SEASIDE AVE., PEAKS ISLAND 94-2-12-13

Memorandum from Department of Building Inspection, Portland, Maine
Seashore Avenue, Peaks Island (Mrs. J. Edmund Hurley)--Construction of 12-foot dormer
window on cottage for Mrs. J. Edmund Hurley by F. W. Stephenson,
builder--11/2/40

SIDE VIEW

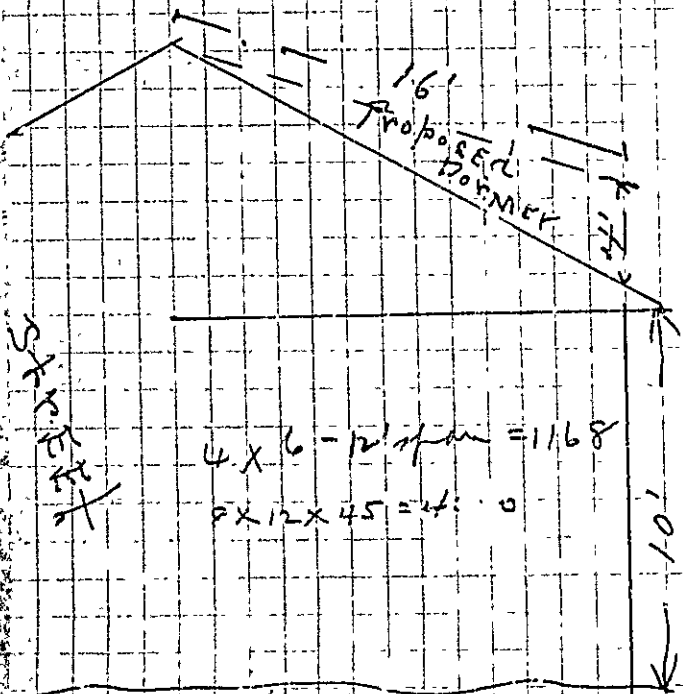
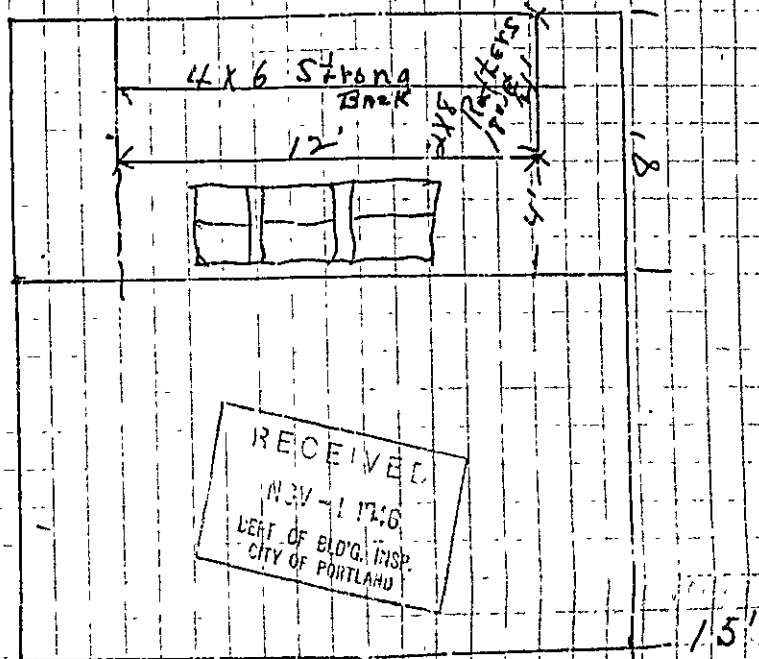
I do not understand just how you intend to support this dormer roof down through the building and at the same time tie the face of the dormer across to the other side of the roof.

If you are able to give us a complete framing plan both of present roof and of proposed framing, showing all essential details and including necessary plan view and cross-section and including the header over the triple mullion window, it would help materially.

The pitch of this new roof will be so slight that it is necessary to consider it structurally as practically a flat roof which means that extra steps must be taken to support the new rafters at the ridge down through the building to the ground, and to tie the base of the new rafters across the building to offset the spread of the rafters and avoid possibility of pushing the top of the face of the dormer outwards. Your sketch contains no answer to these questions, neither are we able to determine from it what would support 4x6 "strong back" under either end down through the building to the ground.

The 4x6 "strong back" shown on the plan, apparently would be supported only under each end. On this basis the beam would be on a 12-foot span and would be very far short of the strength needed to support the 2x8 rafters in their centers, the strength of the beam being about 1200 pounds and the weight which must be contemplated being over 4000. Obviously some other method than the one you propose will have to be adopted, and I suggest that you get this worked out and the information furnished here while you are waiting for our inspector to get to the Island.
